## DEVELOPMENT APPLICATION ASSESSMENT REPORT

Application Number:	DA2022/0717
---------------------	-------------

Responsible Officer:	Alex Keller
Land to be developed (Address):	Lot 2 DP 402645, 101 Old Pittwater Road BROOKVALE NSW 2100 Lot 3 DP 402645, 101 Old Pittwater Road BROOKVALE NSW 2100 Lot 4 DP 402645, 101 Old Pittwater Road BROOKVALE NSW 2100 Lot 1 DP 402645, 99 Old Pittwater Road BROOKVALE NSW 2100
Proposed Development:	Demolition works and construction of a mixed use development comprising self-storage units and industrial units including lot consolidation
Zoning:	Warringah LEP2011 - Land zoned IN1 General Industrial
Development Permissible:	Yes
Existing Use Rights:	No
Consent Authority:	Northern Beaches Council
Delegation Level:	NBLPP
Land and Environment Court Action:	No
Owner:	Veloday Pty Ltd
Applicant:	The Trustee For Brookvale Studios Unit Trust

Image: The 11m height line is shown in red on the south elevation image.

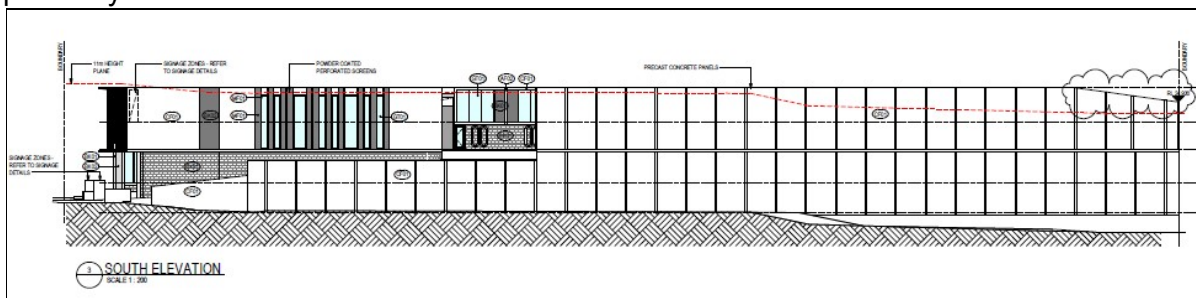
Standard	Requirement	Proposed	% Variation	Complies
Height of Buildings:	11m	11.0m - 13.27m	20.63%	No

The site has not been deeply excavated and NGL is consistent with the existing building ground floor presently on the site.

Image: Height blanket depicting the extent of non-compliance above the 11m height control.

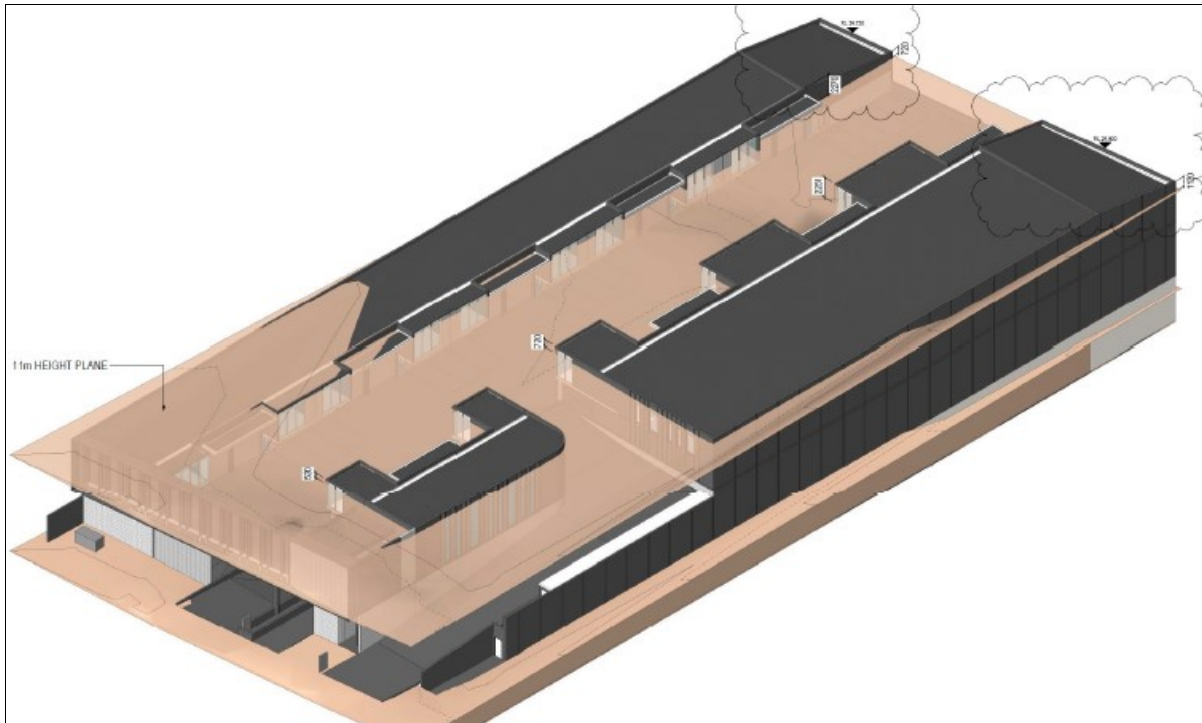
- Focusing on this upper level height variation, the design have been amended to taper down the rear section to the eastern wall to reduce the non-compliant are where it would otherwise be at its highest variation.

- The height blanket image below illustrates the proposed building in context with the building scale and bulk across the width of the 11m height plane and elements of the building proportions that exceed the control along either side of the centre aisle.

In this regard, the applicant's written request has demonstrated that the proposed development is an orderly and economic use and development of the land, and that the structure is of a 'good design' in accommodating site constraints in combination with minimising the visual appearance of non-compliance to the planning controls that will reasonably protect and improve the amenity of the surrounding built environment, therefore satisfying cls 1.3 (c) and (g) of the EPA Act.

As such, the applicant's written request has adequately demonstrated that there are sufficient environmental planning grounds to justify contravening the development standard as required by cl 4.6 (3)(b), and Council can be satisfied that the applicant's written request has adequately addressed the matters required to be demonstrated by cl 4.6(3).

Image: Height of building is limited to the rear section of the land and is commensurate with natural ground level variation.

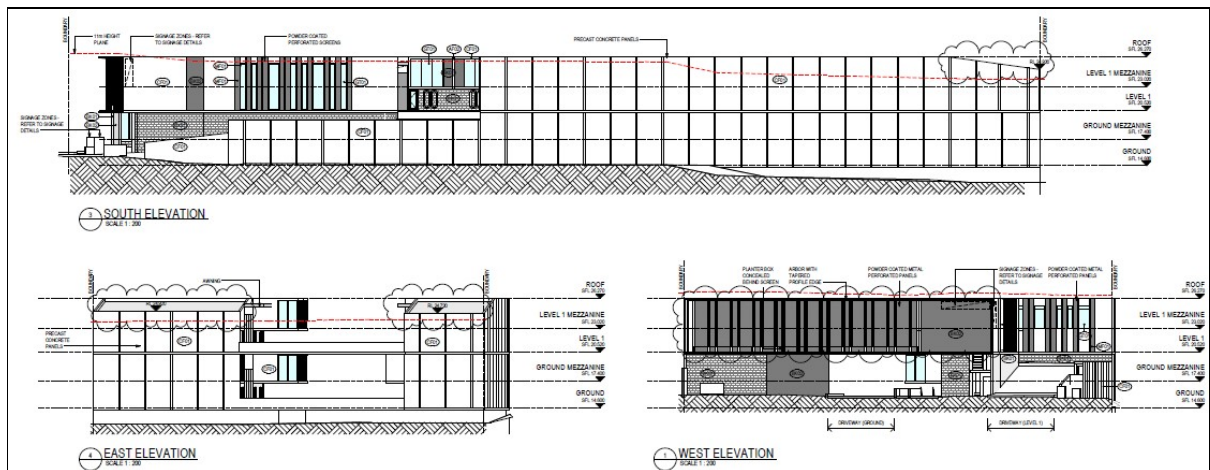
The proposed building represents a sufficient industrial character and the height and bulk has not been over-accentuated above the height control. The character of the area includes an 11m height limit and while there is no storey limit there is a mix of lower single storey and two and three storey buildings present also nearby. The proposal has been amended to taper down the rear wall and non-compliant elements in terms of the upper section of Unit 26 and Unit 34 that extend above the height line. The proposal will be able to establish a landscape setting within the full 4.5m setback and sustain trees at the front that are commensurate with the scale of the building to ensure the development does not have an adverse effect on the streetscape and future character of Brookvale.

Image: Extent of non-compliance along the 4.5m line shown with limited encroachment of fa

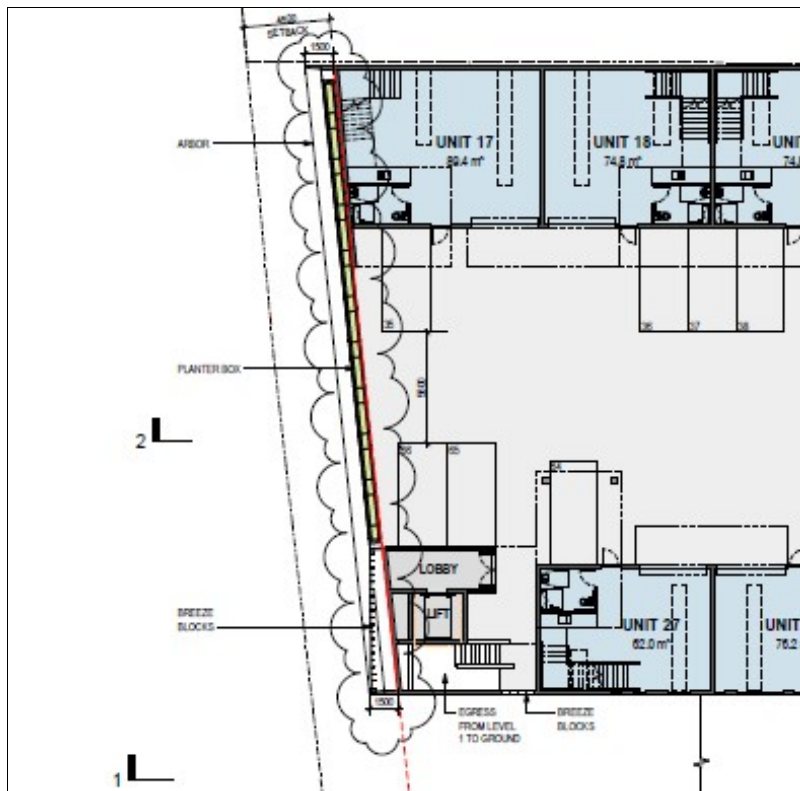
The site is within a busy sector of Brookvale and the extent of non-compliance into the front setback is minimal for part of the street façade elements. At ground level the building is positioned behind a 4.5m width of landscape elements. The proposal is consistent with recent development that have provided landscaped setbacks to the street and ensured meaningful landscaped elements along the streetscape for their re-developed frontages. (examples include No.117 Old Pittwater Road, No.1 to 15 Green Street and No.2 Cross Street).
